Access Compliance Report

Public Rights-of-Way

(Curb Ramps)

Intersection ID: 10370	Main Street: SOLOMON_ST	Cross Street: W_TRADE_ST	Location:	N
ADA ID: 1E64C26CEA94	Ramp Type: Perp	Initial Pass/Fail: Fail	Overall Compliance: No	Severity Score: 22.5
Codes/Mitigation Info/Possible Solution		Field Measurements/Component Compliance

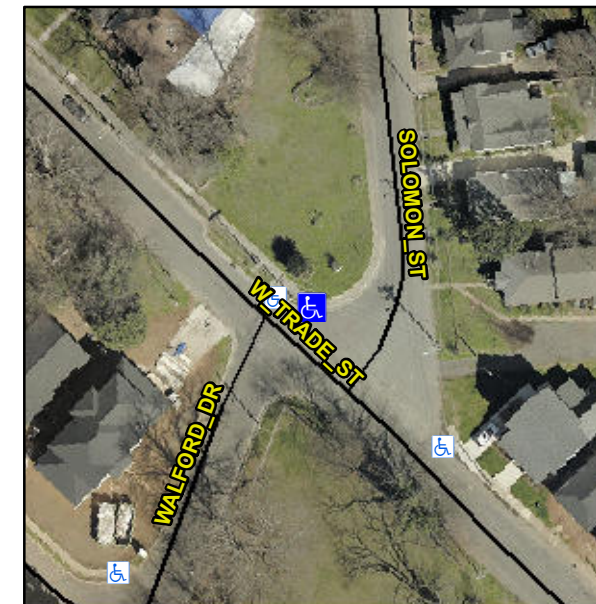
Not Found, R304.5.1, R304.2.2, R304.5.3

Compliance	Description	Data	Compliance	Description	Data
N/A	Ramp Length (in)	56.0	No	Ramp Slope (%)	8.8
No	Ramp Width (in)	46.0	No	Ramp XSlope (%)	3.0
N/A	Flare Type LT	N/A	N/A	Flare Type RT	N/A
N/A	Flare Slope LT (%)	N/A	N/A	Flare Slope RT (%)	N/A
N/A	Flare Traversable LT?	N/A	N/A	Flare Traversable RT?	N/A
N/A	Landing Length (in)	N/A	N/A	DWS Provided?	N/A
N/A	Landing Width (in)	N/A	N/A	DWS Contrast?	N/A
N/A	Landing Slope (%)	N/A	N/A	DWS Length (in)	N/A
N/A	Landing X Slope (%)	N/A	N/A	DWS Full Width?	N/A
N/A	Landing Curb? (Y/N)	N/A	N/A	DWS Offset (in)	N/A
N/A	Shared Landing?	N/A			
N/A	Gutter Ponding?	N/A	N/A	Gutter Slope (%)	N/A
N/A	Gutter Lip Ht (in)	0.5	N/A	Gutter X Slope (%)	N/A
N/A	Painted X Walk1?	No	N/A	Painted X Walk2?	N/A
	X Walk 1 Direction	To SE		X Walk 2 Direction	N/A
N/A	X Walk 1 Width (in)	N/A	N/A	X Walk 2 Width (in)	N/A
	X Walk 1 Slope (%)	0.8		X Walk 2 Slope (%)	N/A
	X Walk 1 X Slope (%)	3.1		X Walk 2 X Slope (%)	N/A

Remove & Replace Entire Ramp.
